SERVICE Counselor

PACKARD MOTOR CAR COMPANY

JANUARY, 1954

REAR QUARTER WINDOW REGULATOR

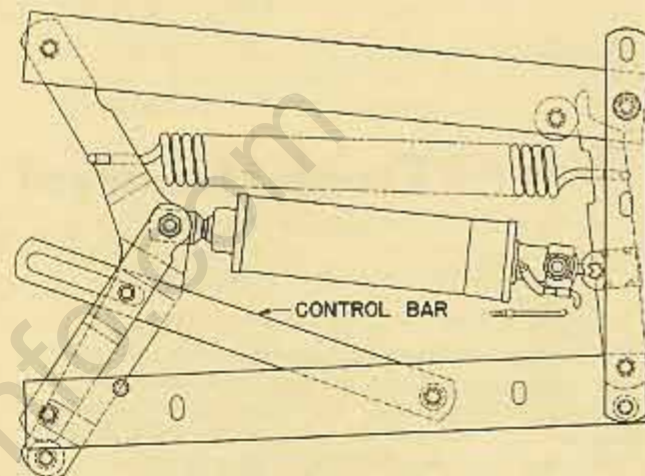
In checking rear quarter window hydraulic cylinders that were returned from the field because of fluid leaks, it has been found that most of the cylinders were leaking at the end plates because the plates were loose, cracked or distorted.

If the window pivot bracket does not contact the stop screw when the window is in the raised position, the piston is permitted to travel to the extreme end of the cylinder. When this occurs and the car is subjected to a temperature rise, the hydraulic fluid expands enough to move the piston against the end plate with such force that the plate is distorted and loosened.

A control bar with a slotted end has been added to the hydraulic window regulator which controls the amount of cylinder travel. "See illustration." Stop screw adjustments are still required to control window travel.

Whenever rear quarter window hydraulic cylinder failure is encountered due to end plate leaks, it is suggested that a new regulator having the control bar also be installed.

Installation Instruction—Change

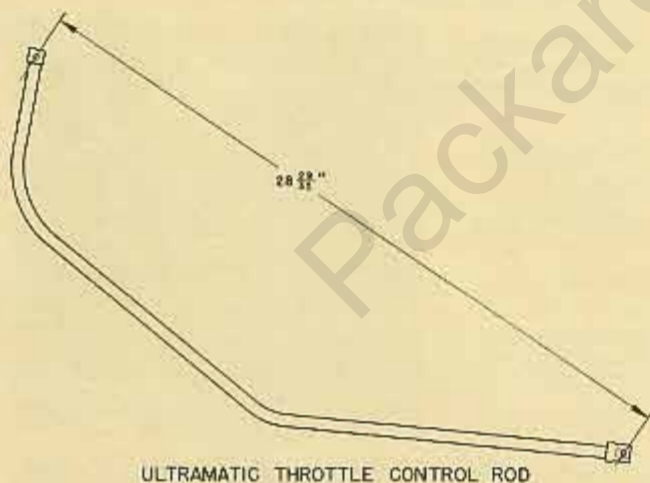
An installation instruction change has been made in the location to connect the windshield washer feed wire. This is the wire in which a fuse is attached.

The instructions furnished with the kits under item 3 "WIRING" states that the windshield washer feed wire is to be connected to the ignition switch. *The feed wire should be connected to the battery terminal of the 10 amp. circuit breaker. The 10 amp. circuit breaker is the one nearest the temperature gauge.*

"Note Fig. 1 and attach short end of wire "E" (in which fuse is attached) to "feed" post on 10 amp. circuit breaker, then run other end of wire through hole in dash and connect to pigtail terminal running to top of washer jar, nearest to center. Assemble cable "F" through hole in dash and connect Douglas female to pigtail on top of washer jar farthest from center and make connection of other end with male terminal "G" on end of wire running from steering post washer knob. Strap to windshield wiper motor control cable Bowden wire."
